Catawba Nuclear Station COLR

Catawba Unit 2 Cycle ~~5~~⁶

Core Operating Limits Report

November 22, 1991

Figure 5
Catawba Unit 2 Cycle 5
RAOC W(Z) at 150 MWD/MTU
8-146

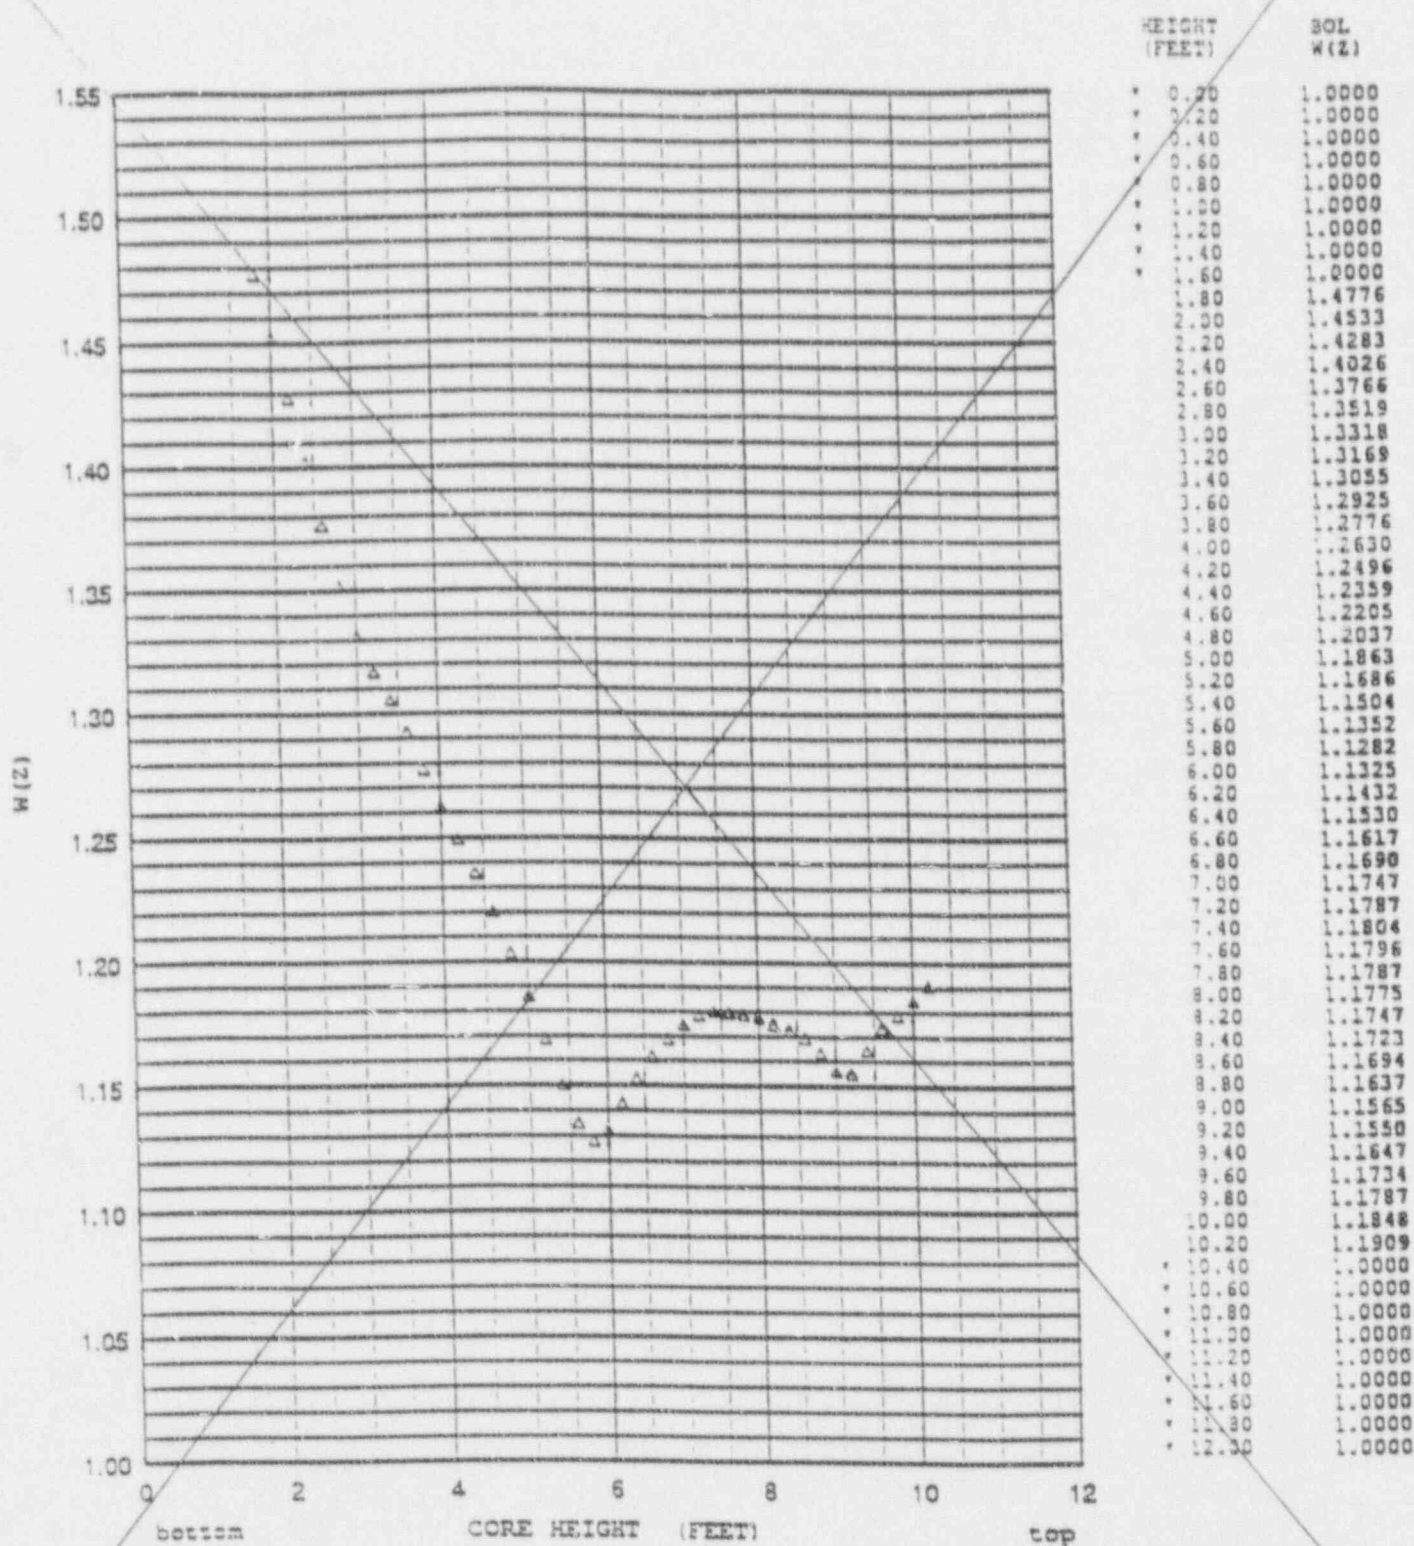
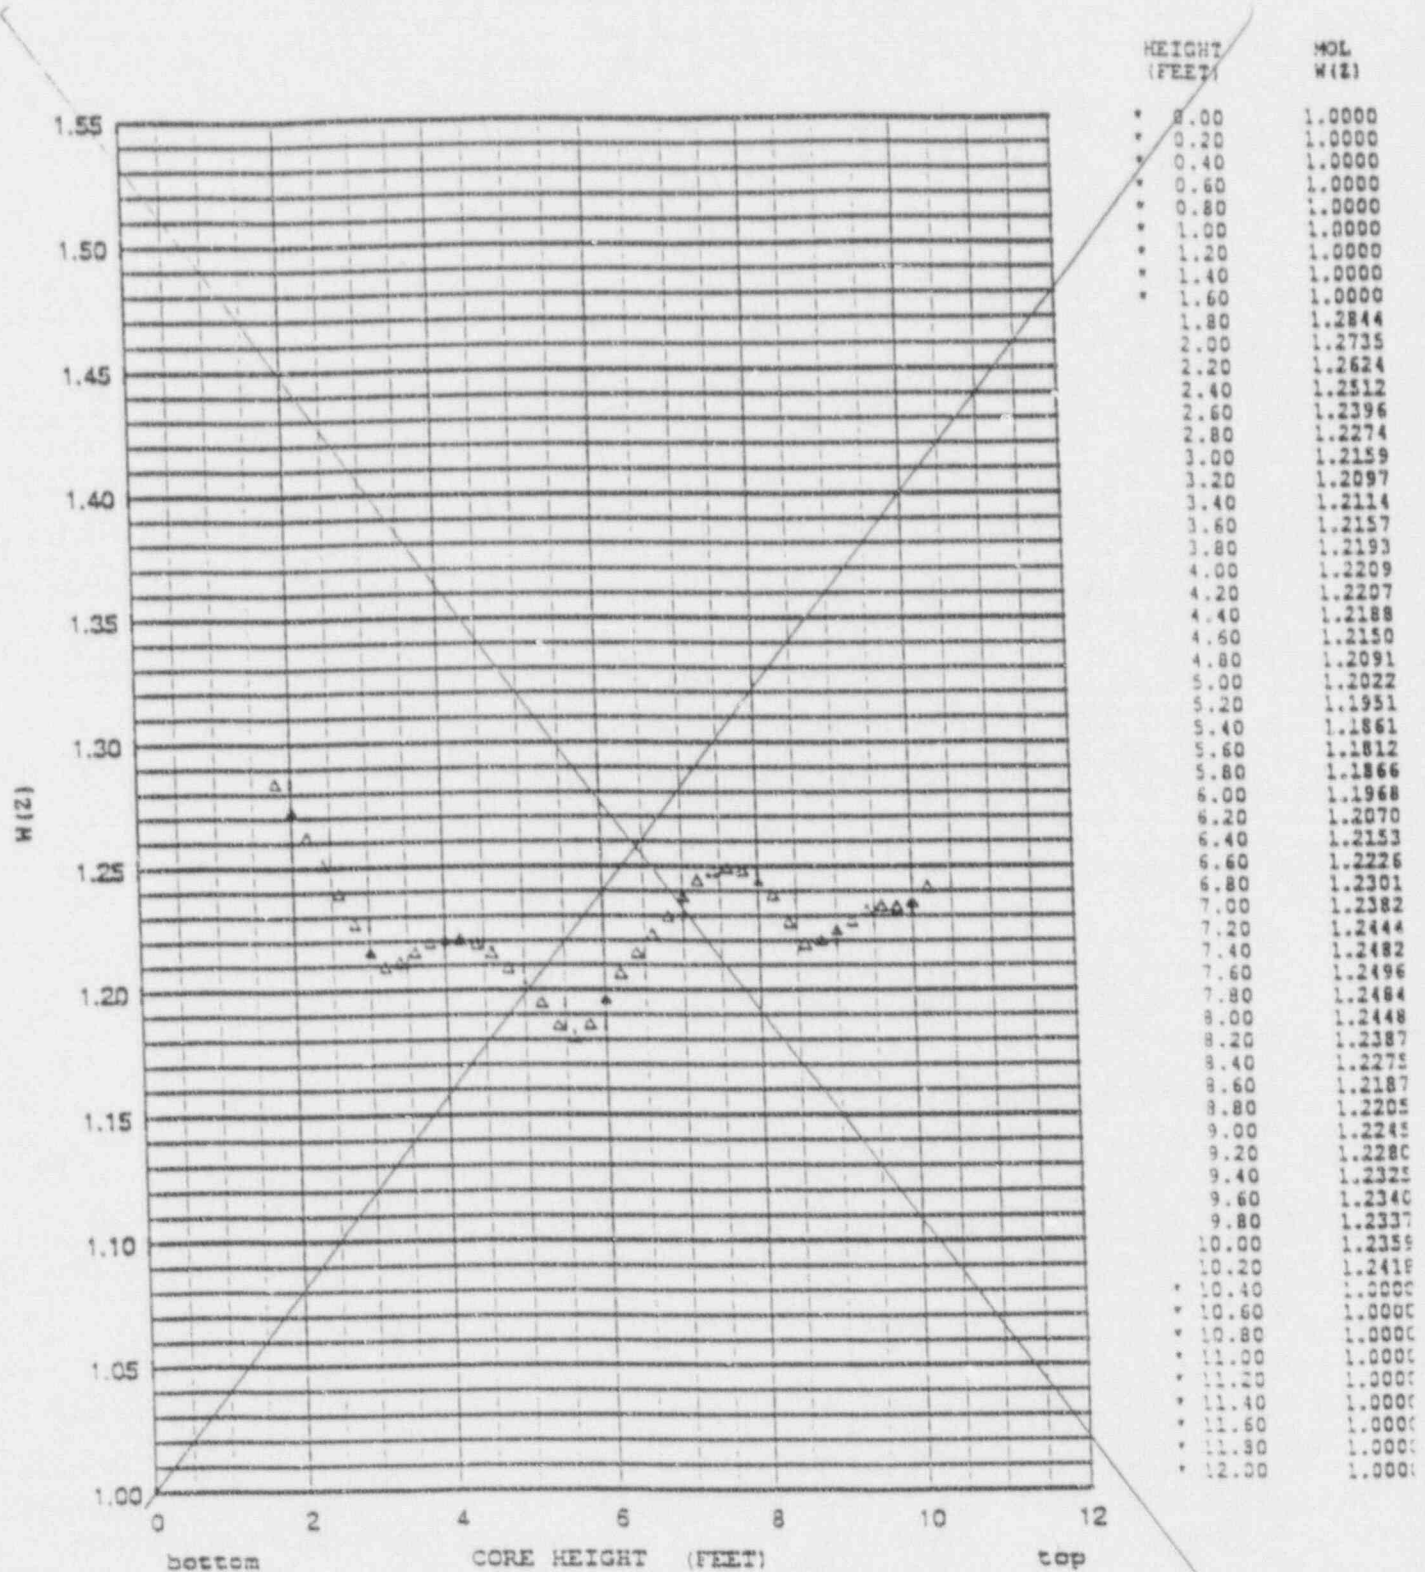
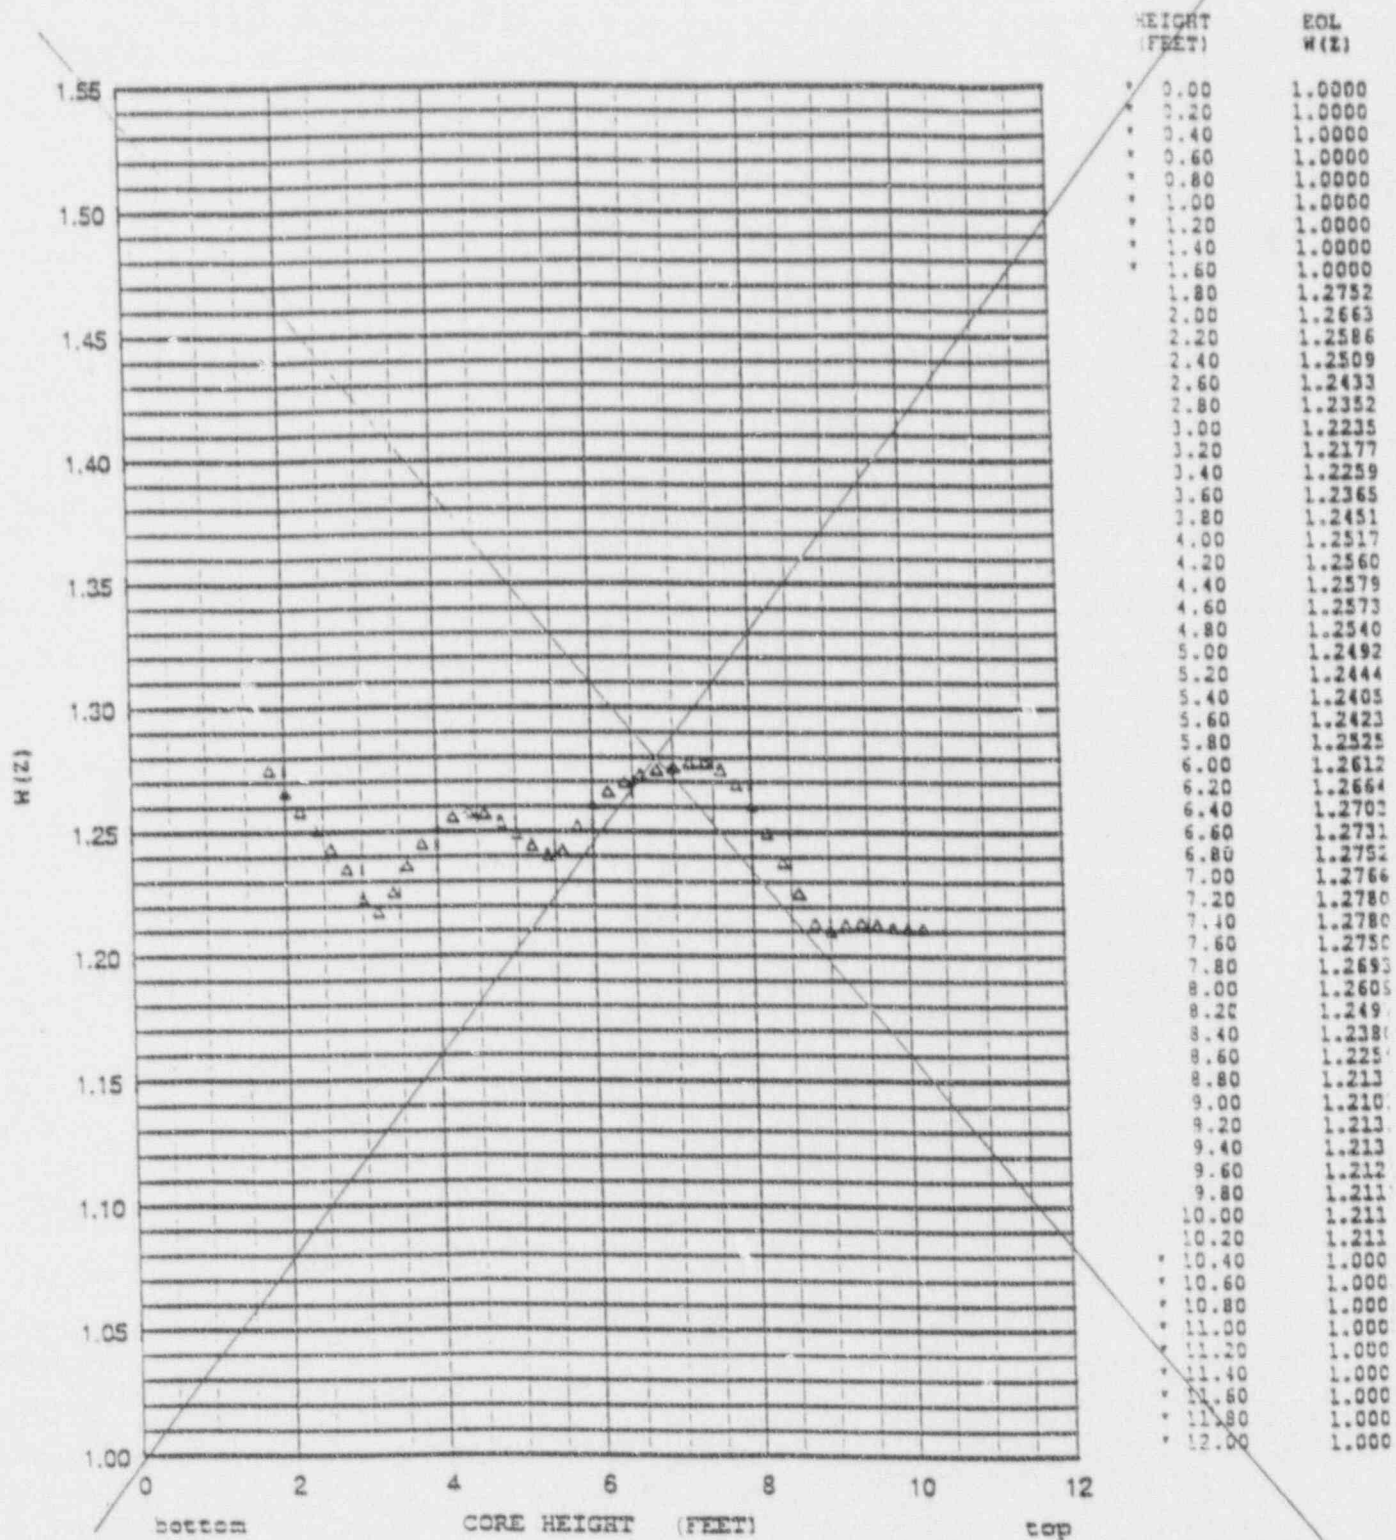
Replace with
Insert 5

2.5.3 $W(Z)$ values are provided in Figures 5 through 7.

2.5.4 Base load $W(Z)$'s are not applicable for Catawba 2 Cycle 5.

Insert 5

Figure 8
RCS Flow vs. R-Four Loops in Operation

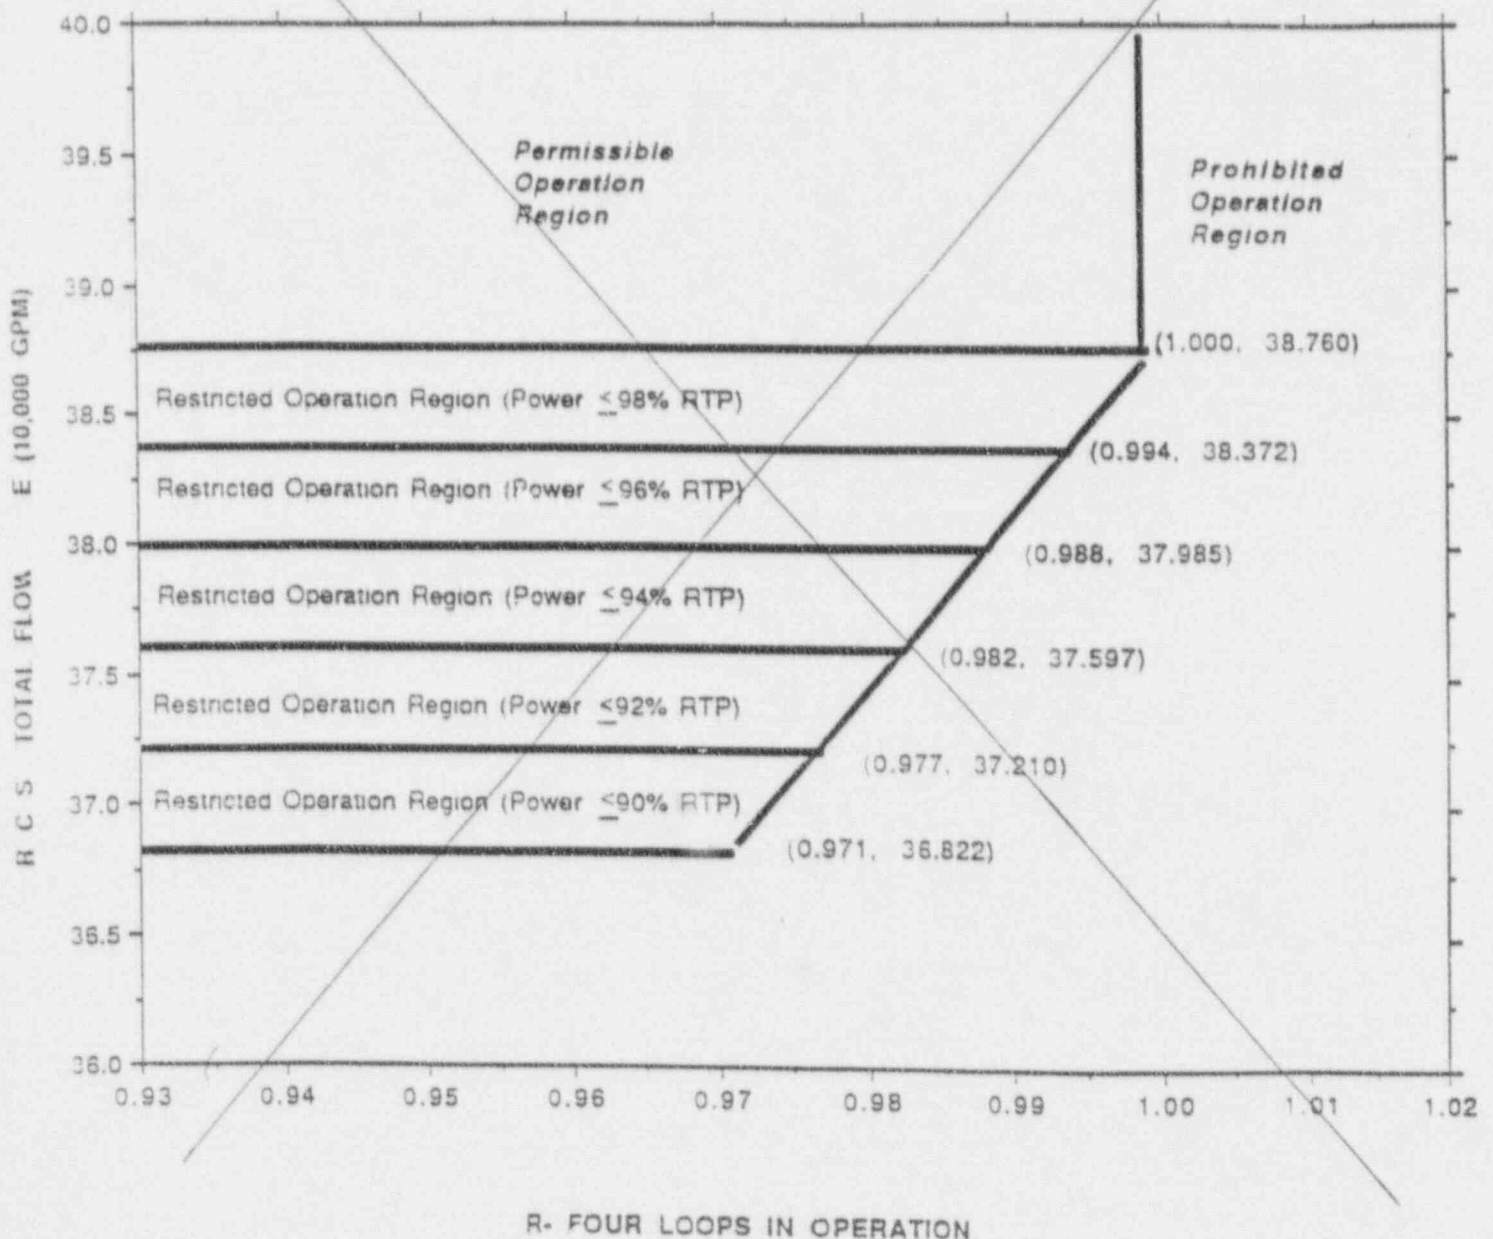
Replace with
Insert 7

2.6.3 The Acceptable Operation Region from the combination of Reactor Coolant System total flow and R is provided in Figure 8.

Insert 7
